Auckland Council

Papakura Stream Flood Hazard Modelling – Sunfield Development

24 September 2025

Papakura Stream Plan Change Modelling Support

Figure 2-8: Snip from M-C4602, reproduced from applicant's lodged document. Box culvert location shown.

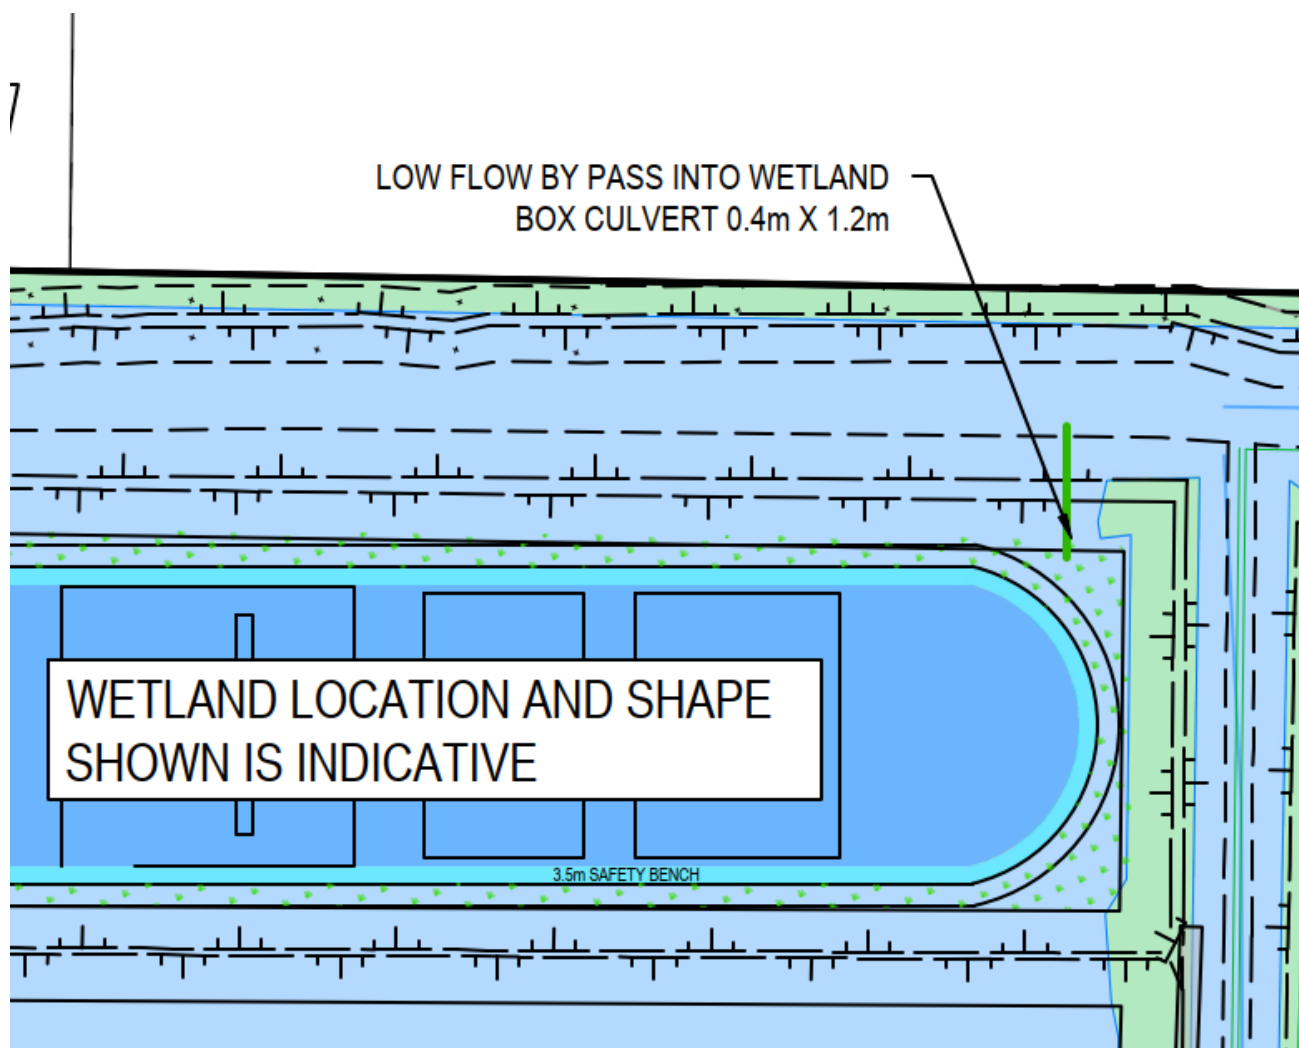
The drawing M-C4602 shows a box culvert connecting the diversion channel to the 10-year ARI basin of pond 1, as shown in Figure 2-8. The drawing does not show the invert of this box culvert, and no further information is provided. We have therefore assumed that this is an open culvert (no flap gates) at the invert level of the pond.

7. Pond 1 box culvert – The box culvert inlet to the 10-year ARI basin of pond 1. This is a critical structure which controls how the pond will operate, whether it can perform as described and therefore whether the development is feasible from a stormwater perspective. The applicant did not provide details for this structure. We have assumed this is a box culvert at the invert of pond, with no flow controls (i.e. flap gates or similar).

Figure 2-10: Pond 1 Outfall weir profile.

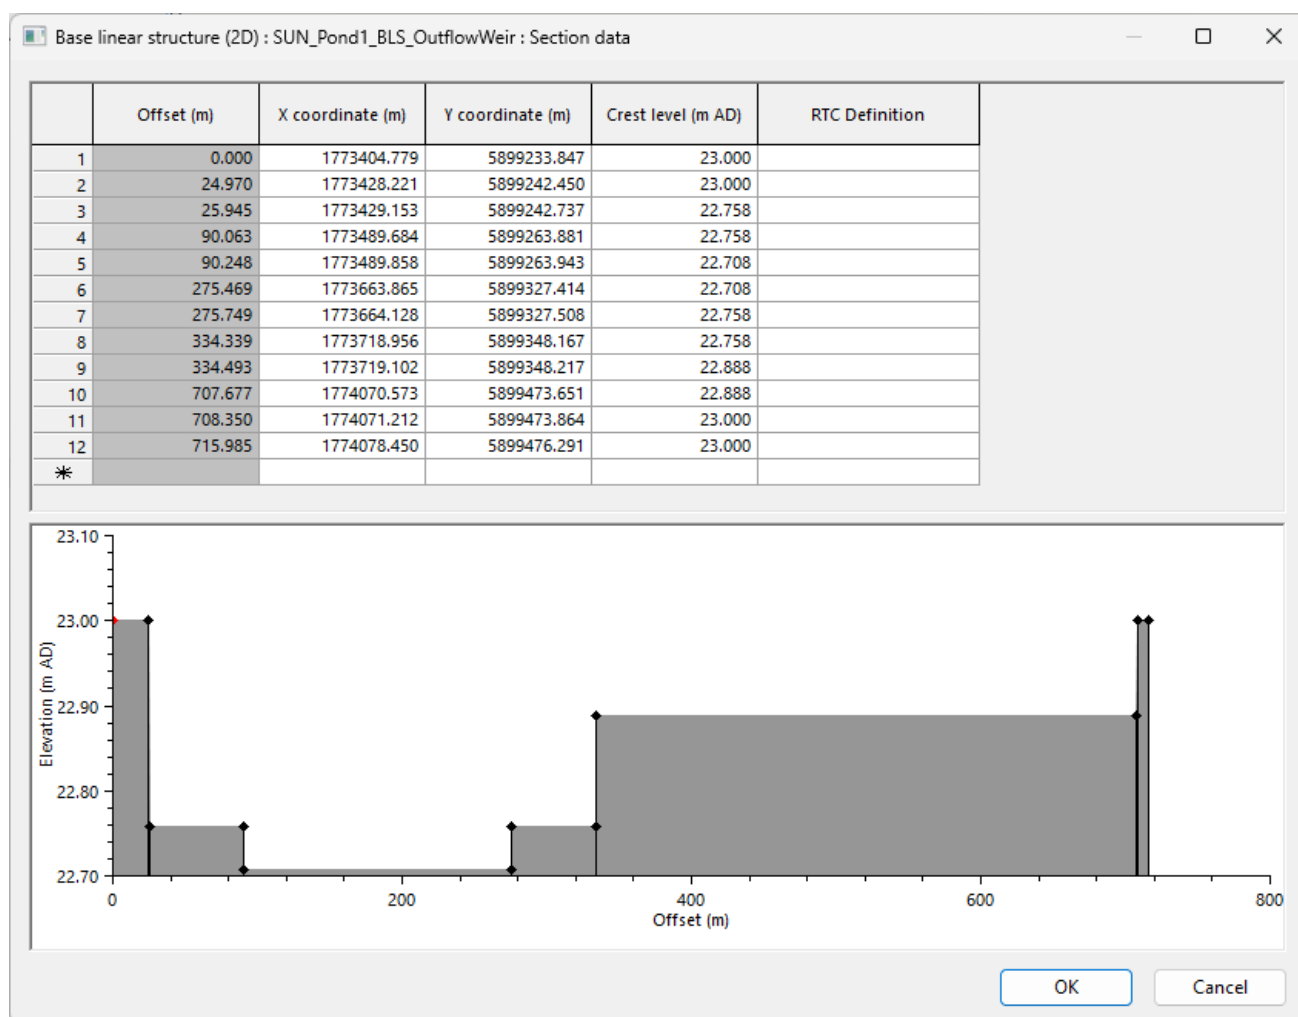
Note a label on M-C4605 drawings states that the 22.47m AD (NZVD2016) section of bund is 20m long, however the geometry length is close to 60m long. This difference results in a significant change in the performance of the bund. We have assumed that the geometry is correct, and that the label is wrong. This is shown as the second section of 22.758m AD (AUK46) weir in Figure 2-10.

8. Pond 1 weirs modelled as broad crested weirs, with 2m crest width in ICM hydraulic model.
9. Pond 1 outflow weir: Drawn as scaled from drawing M-C4605. A label on the drawings states that the 22.47m AD (NZVD2016) section of bund is 20m long, however the geometry length is close to 60m long. This difference results in a significant change in the performance of the bund. We have assumed that the geometry is correct, and that the label is wrong.

Figure 6-2: Proposed overland flow path through Sunfield development site – 2-year CN61 E+SUN.

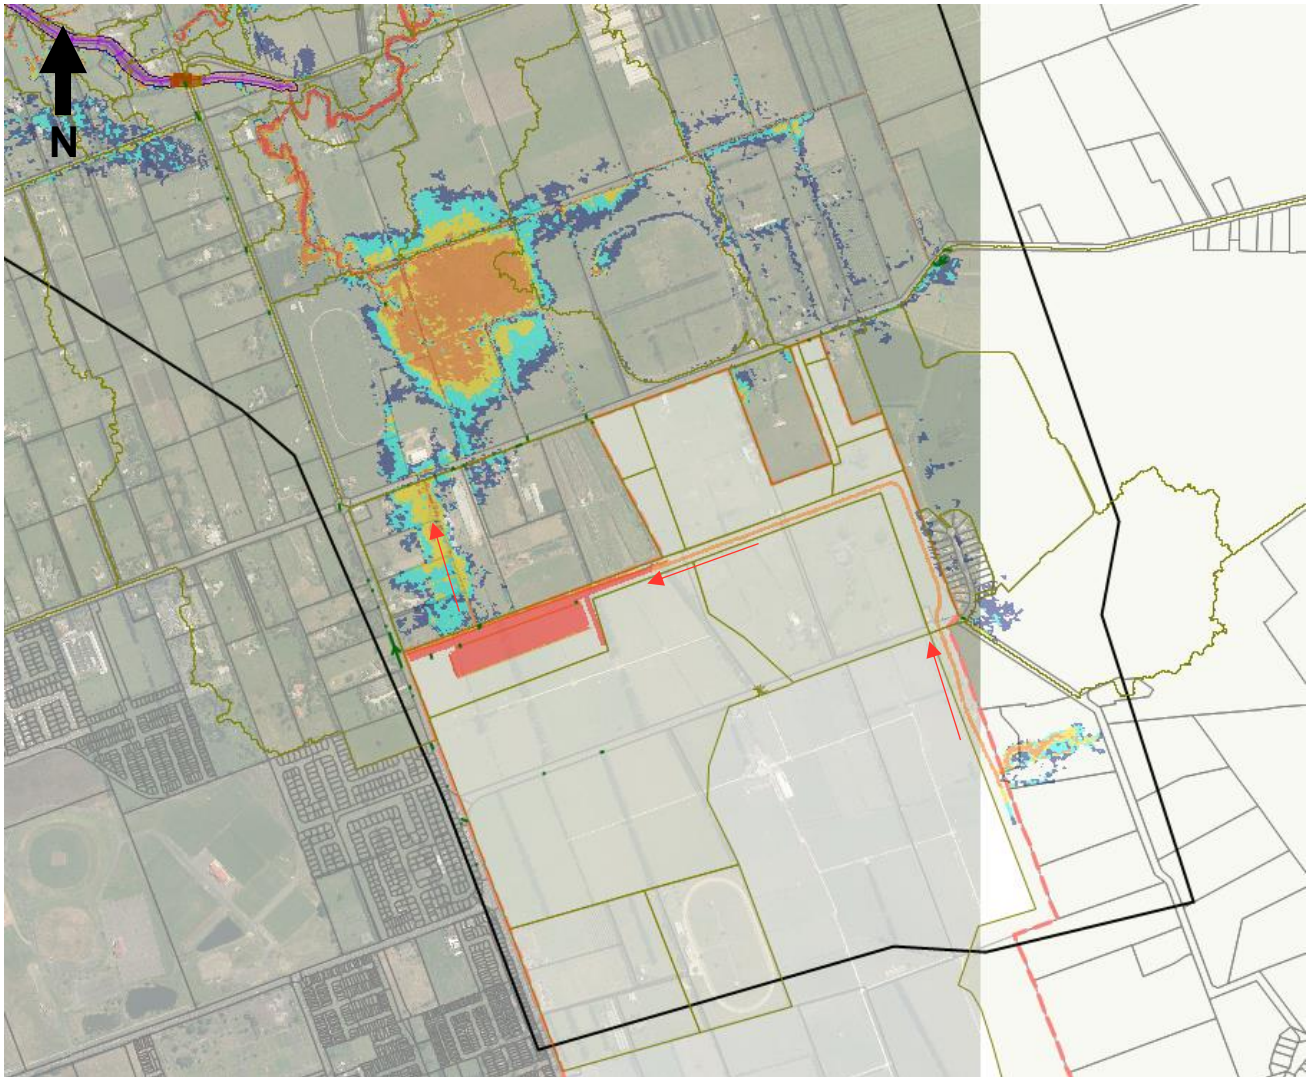
The applicant proposes to collect and discharge all the upstream rural flows through the diversion channel into pond 1. This will concentrate the current overland flow paths and discharge them all into private property at one location.

Since the proposal involves concentrating the overland flow paths into a single location, it is not sufficient to analyse the overall flows and to maintain the total pre-development flow rate. Loading all the flow into one location requires a more in-depth analysis of the current capacity of the open drains immediately downstream of pond 1.

Figure 6-3: Change in predicted peak flood depth in the 2-year ARI, CN61 scenario, showing increase in predicted flood depth downstream of Pond 1.

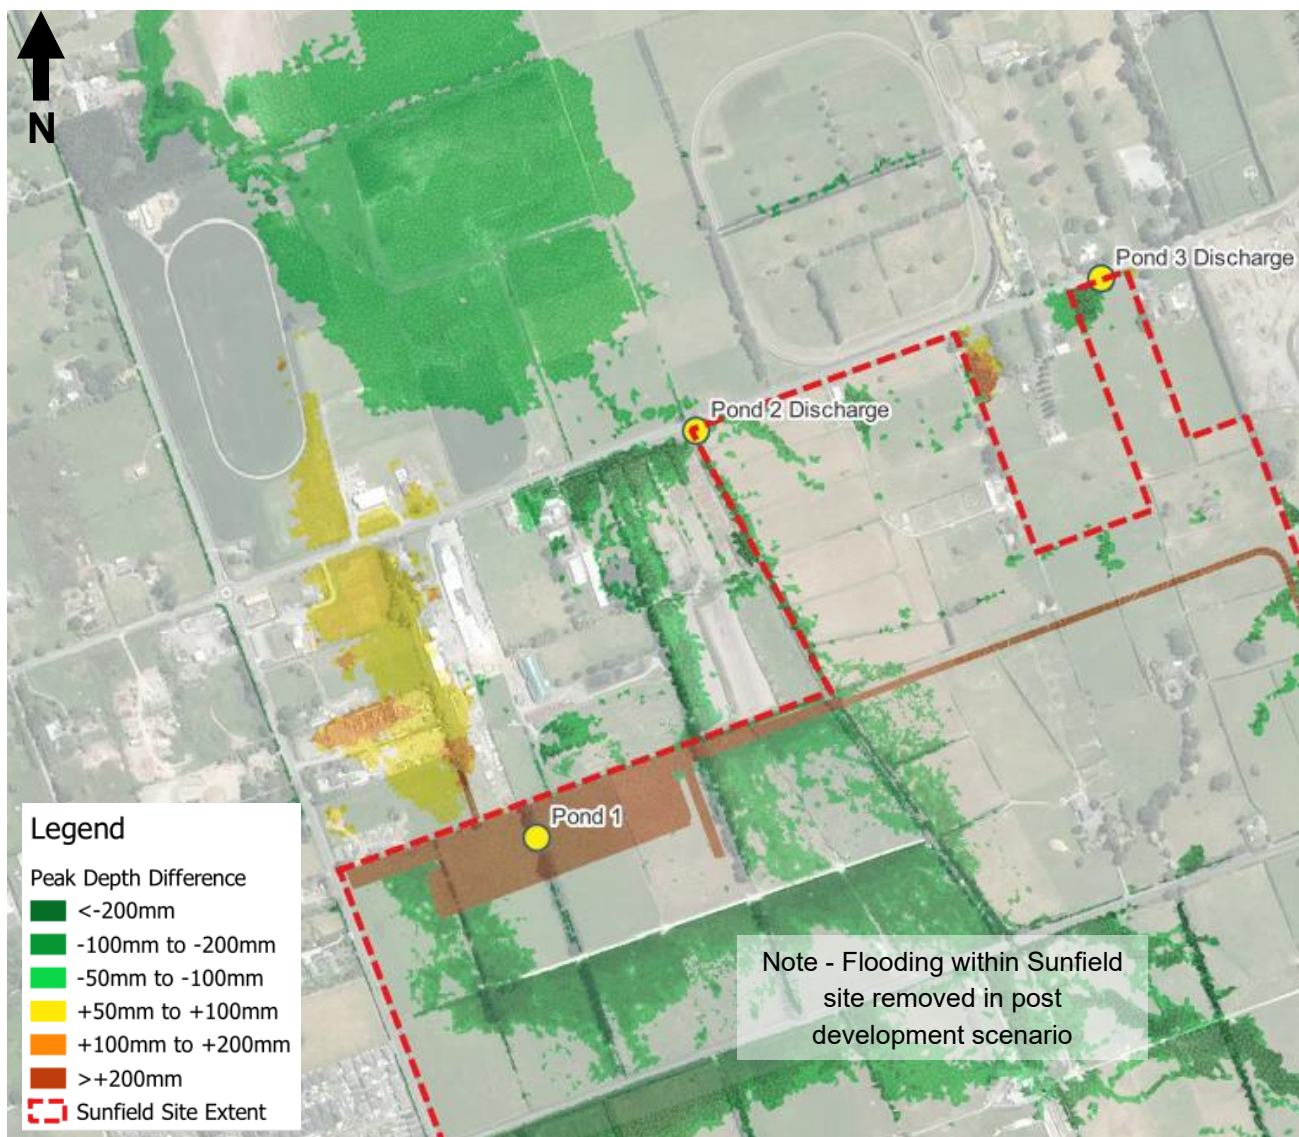
In some scenarios the increase in flood depth is greater than 100mm, and increases the predicted flood hazard to properties downstream. In the 2-year ARI CN61 scenario there is an increase in flood depth of greater than 100 mm downstream of the pond 1 outfall, as shown in Figure 6-3.

Figure 6-4: CN61 10-year ARI historical rainfall – showing predicted flood depth increase at building footprint.

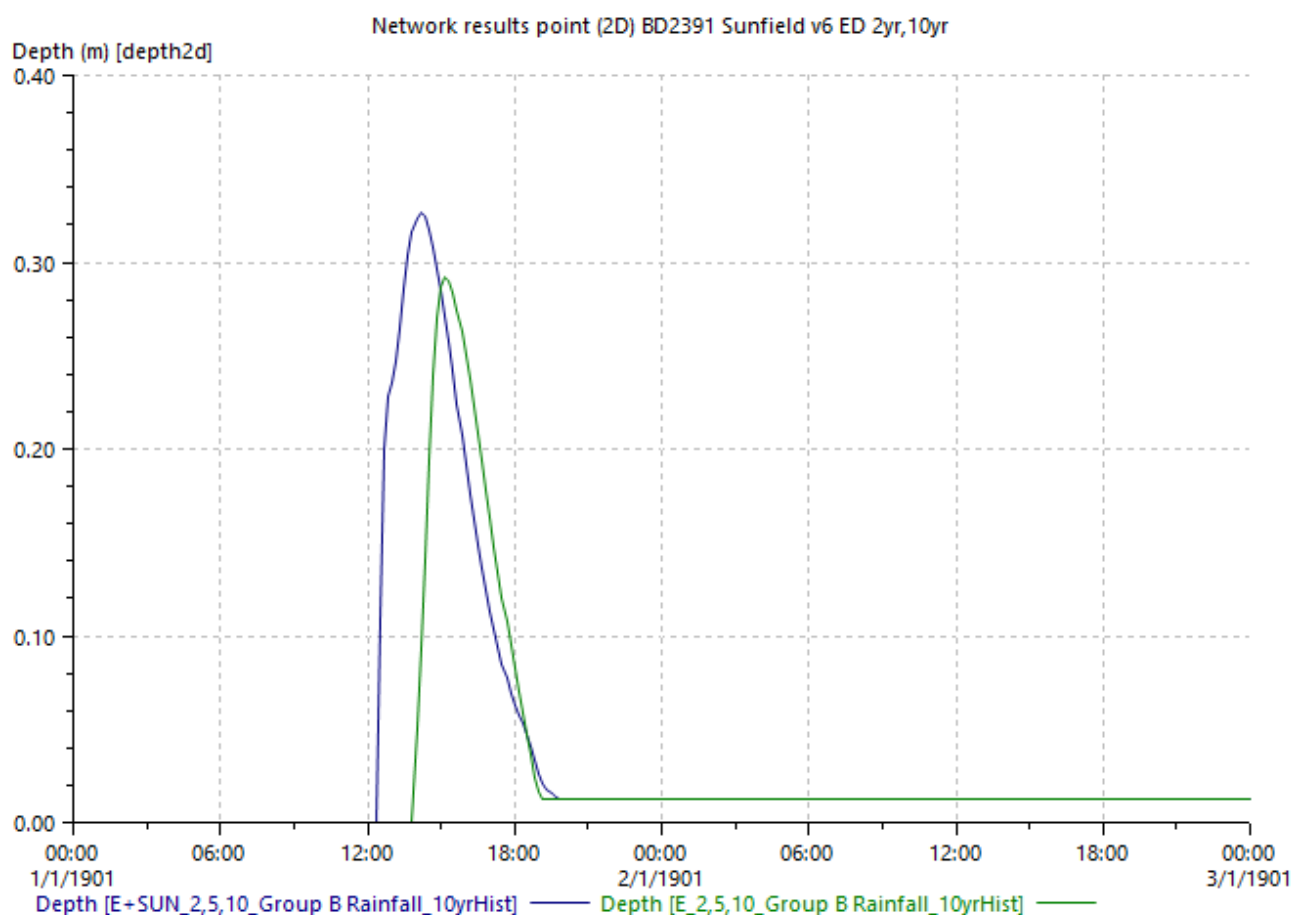
Figure 6-4 shows the increase in predicted flood depth at a building downstream of pond 1 in the 10-year ARI CN61 scenario. The location of this building is shown in Figure 6-5. Note that this result is not apparent on the flood depth difference maps as the increase is less than 50 mm.

Figure 6-8: Predicted operation of pond 2 in 100 year ARI E+SUN scenario, CN 61.

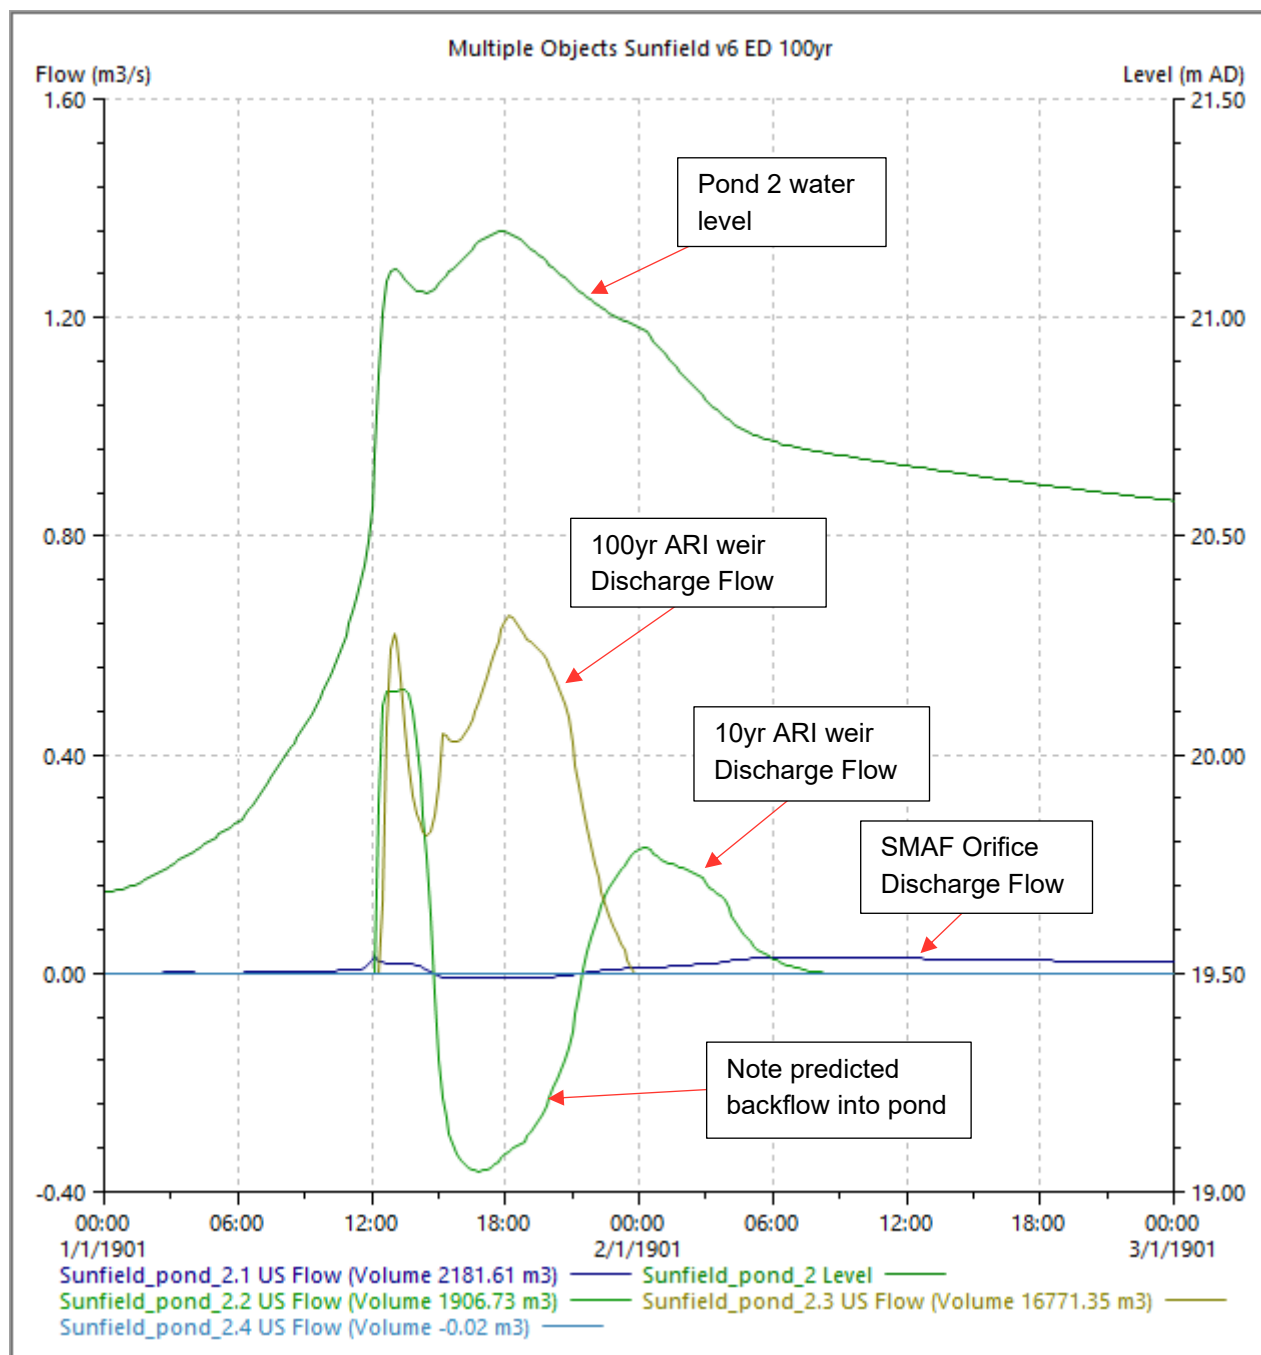
Our modelling indicates some backwater issues at pond 2 and 3. Figure 6-8 shows the flows through the different outlets from Pond 2, as well as the pond level on the secondary Y axis. Due to the high downstream water level the model predicts backflow into the pond via the 2m wider “10 year ARI” weir.

The culvert “Structure 16” is immediately downstream of the proposed pond 2. This culvert was added into the ICM model based on the farm drain survey provided by AC. This structure does not appear to be restricting flows, as the model predicts very similar peak depths on both sides of the culvert. Figure 6-9 shows the water level in pond 2 compared to the water level downstream of the “structure 16” culvert on the north side of Airfield Road.

Figure 6-9: Predicted water level within Pond 2 and downstream north of Airfield Road. 100 year ARI E+SUN CN 61.

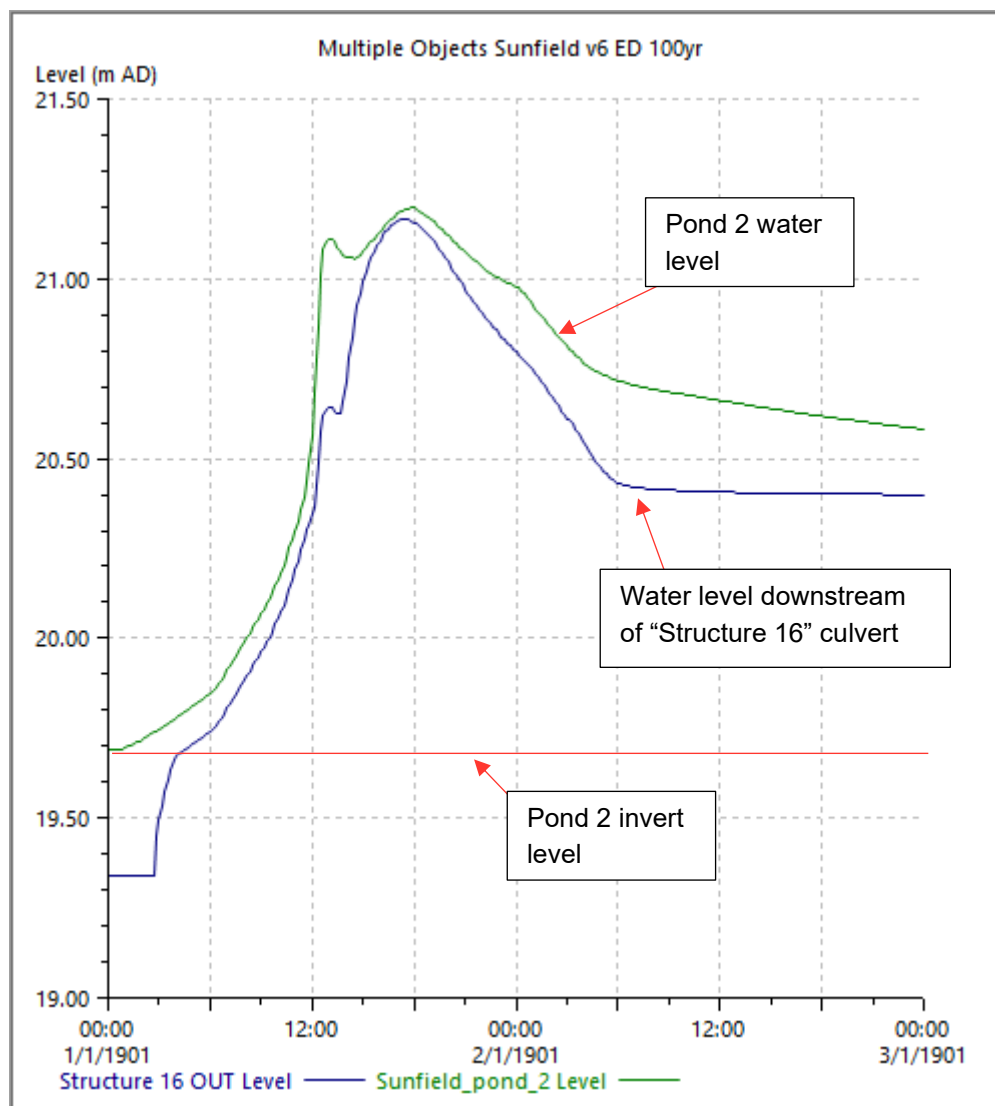
Due to the model not including survey of the open drains downstream of pond 2, we have lower confidence in the model results in smaller rain events (i.e. 2 year ARI). However, in larger (10 and 100 year ARI) rain events, the downstream area floods and therefore the drains become less critical to the result.

The applicant's hydraulic model for ponds 2 and 3 does not appear to consider backwater effects from the downstream flood area. The applicant's report does not discuss this backwater issue. The 3WSR states that the applicant has modelled these ponds in HEC-HMS, and loaded the discharge flows into their HEC-RAS model to assess downstream flood depths. As we have not received their models, we cannot confirm how the interaction between these models was implemented in the applicant's models, and whether backwater effects were considered.
